SOUTH FLORIDA WATER MANAGEMENT DISTRICT

TECHNICAL DOCUMENT TO SUPPORT THE CENTRAL EVERGLADES PLANNING PROJECT EVERGLADES AGRICULTURAL AREA RESERVOIR WATER RESERVATION

Draft Report

~~June~~July 28, -2020

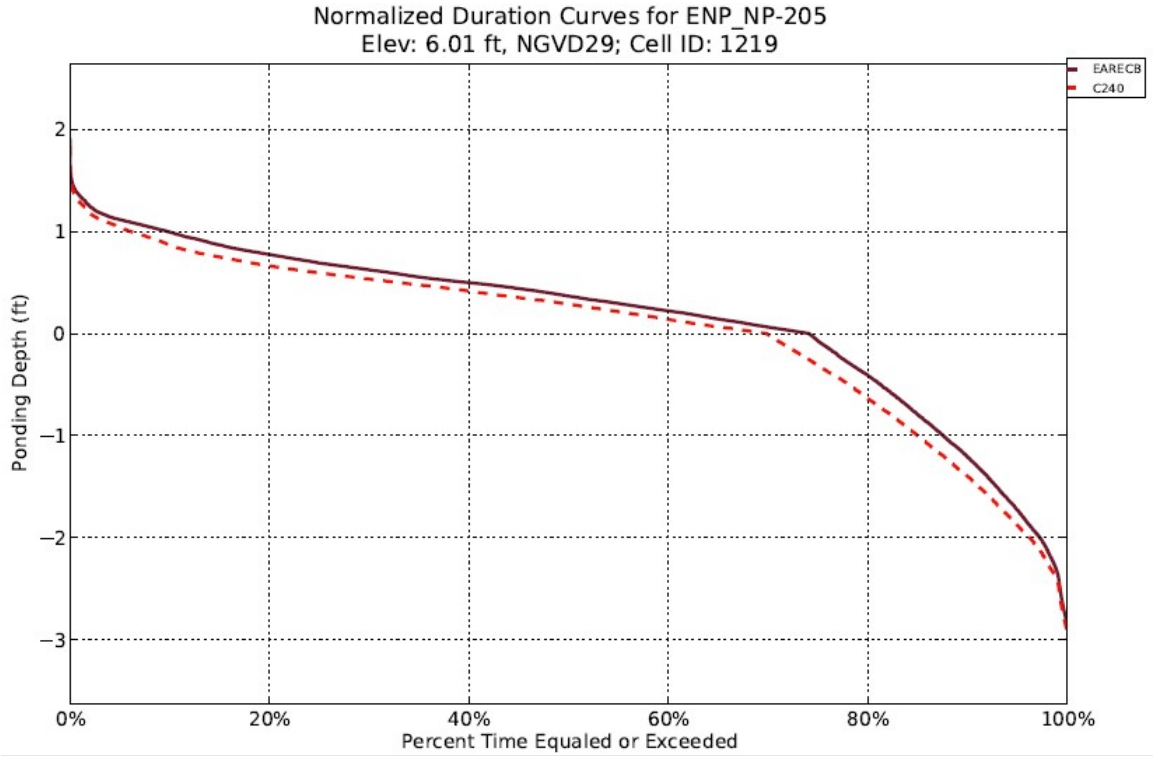
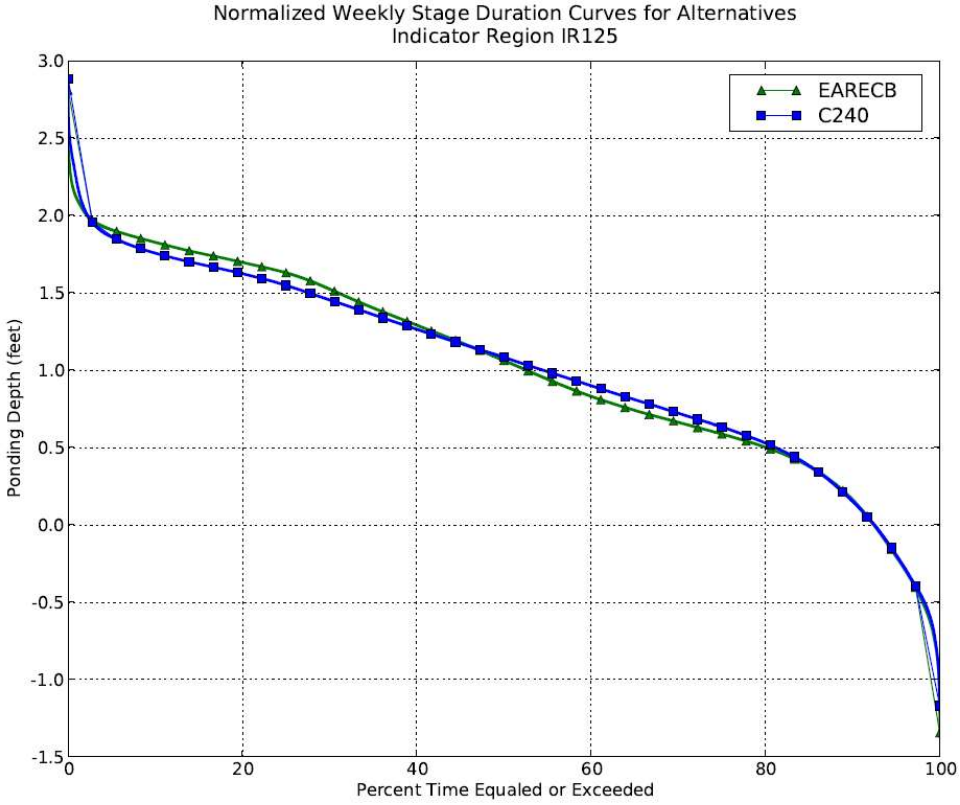
Comment No.	Commenter	Question/Comment	District Response
128	Dr. Nathan Dorn (Peer Reviewer)	Figs. 4-22 and 4-32 are exactly the same figure.	**Dong Yoon Lee:** We will delete Figure 4-32.
129	Dr. Nathan Dorn (Peer Reviewer)	Section 4.2.2. Page 44. The meaning of the last sentence is unclear: "which.." (what effect?) "…can cause a transition to wet prairie and slough/open-water marsh communities." Is the wet prairie a problem? If so, why include "and" in between wet prairie and slough? Which of those two are you hoping to avoid and what causes the transition?	**Dong Yoon Lee:** Agreed. We will clarify the sentence.
130	Dr. Nathan Dorn (Peer Reviewer)	Section 4.3. Throughout: what is the exact meaning of using 1978 as an "average year?" Was that an average precipitation year or an average water depth for the period of record? The start of the section (perhaps on page 47) could use a brief explanation of the limitations of the ecological and modeling evaluations (for some taxa we have no models) and explanation for the choices of evaluation periods or years (e.g., wet, dry, average).	**Clay Brown**: Analyses of rainfall data in central and south Florida using Normal and Log Normal probability distributions were fitted to annual rainfall for the entire District area. The results of the analysis indicates the District receives a regional annual average rainfall of 53 inches, dry annual average of 44.3 inches and wet annual average of 62.5 inches. Using the above statistics as a guide, representative years corresponding to annual District rainfall were selected. In addition, the annual rainfall for the antecedent year should also be considered. In other words, the annual rainfall preceding the "selected" year should also be consistent. In summary, 1978 was selected to represent an average rainfall year, 1989 a dry year and 1995 a wet year. Reference Documents: Alaa, A. and W. Abtew 1999. Regional Rainfall Frequency Analysis for Central and South Florida. Technical Publication WRE #380. South Florida Water Management District. West Palm Beach, Florida; Sculley, S. P. 1986. Frequency Analysis of SFWMD Rainfall. Technical Publication 86-6. South Florida Water Management District. West Palm Beach, Florida. **Dong Yoon Lee**: We will add a brief explanation provided by Clay

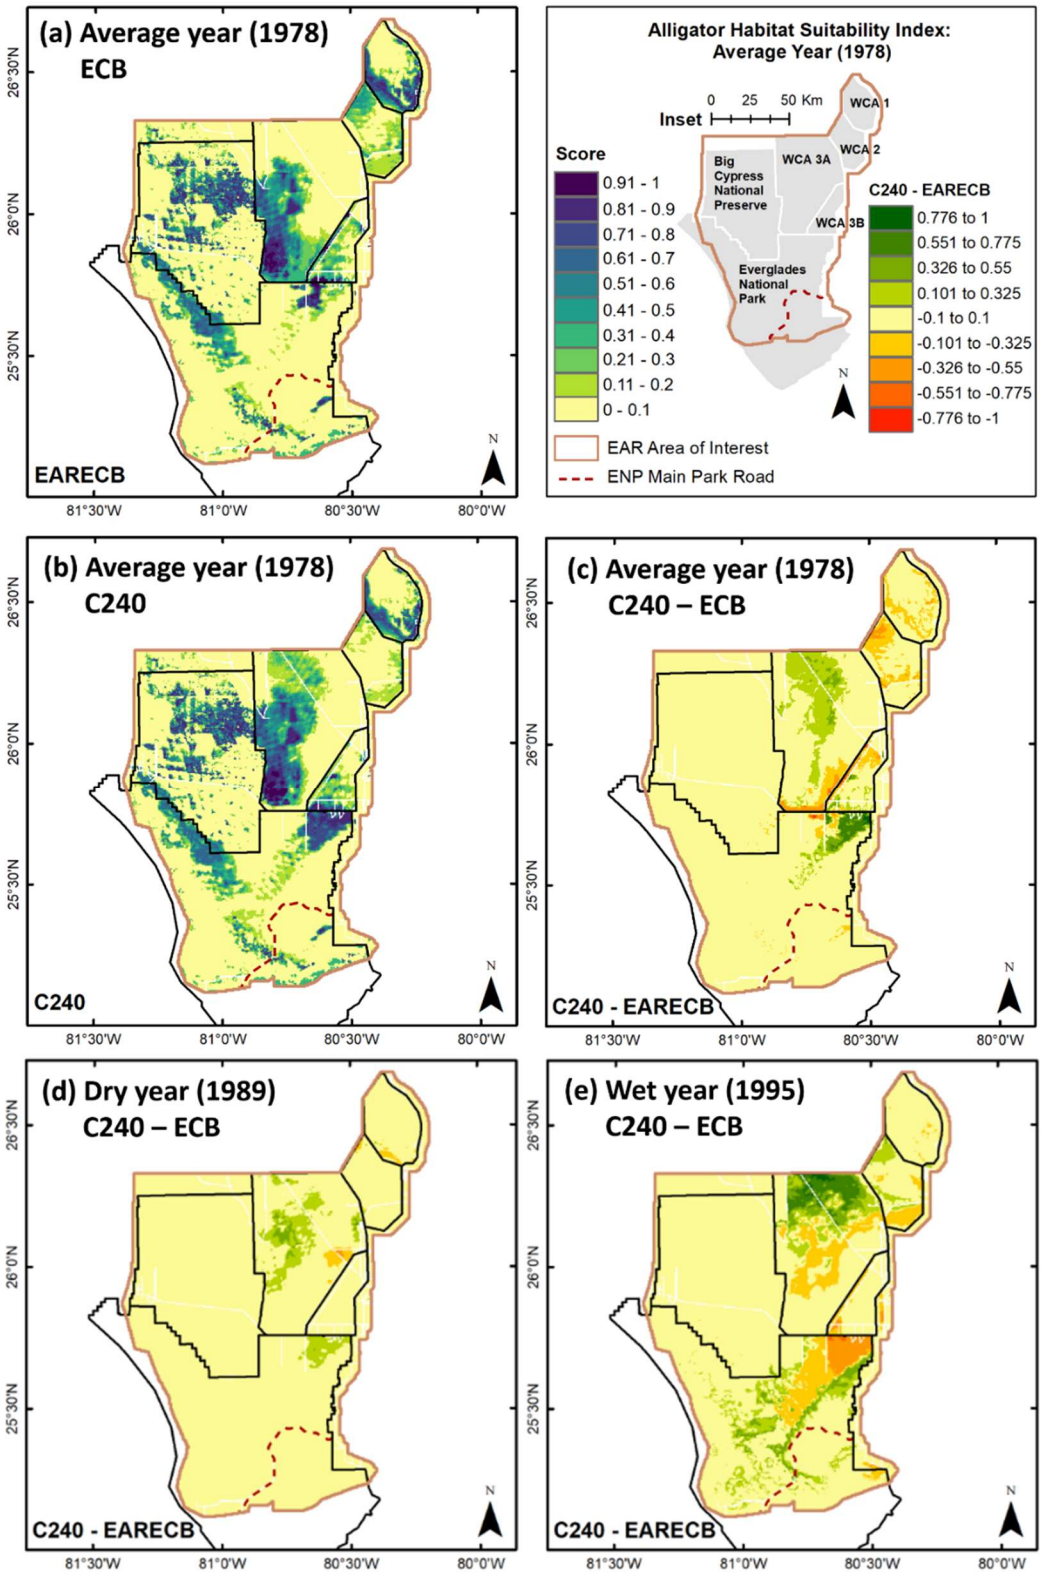
Comment No.	Commenter	Question/Comment	District Response
31	Dr. Nathan Dorn (Peer Reviewer)	As far as the alligator model is concerned it is pretty complex so it will be difficult to figure out what causes the orange areas.	**Dong Yoon Lee:** We will add the new (long-term) hydroperiod map in Figure 4-2. This new map will help explain the ecological model output.
32	Dr. Donald DeAngelis (Peer Reviewer)	For wading birds, there is a paper by (3 authors he mentioned in Restoration Ecology)...is there any connection between what they used and what is being used here?	**Dong Yoon Lee:** The paper is Beerens, Trexler, and Catano (2017). This paper simulated the wading bird foraging index under the full (CERP) and partial (scaled-back CERP) restoration relative to the existing condition. They simulated the ecological model over a 36-year period, while we have a longer (41 years) simulation period.
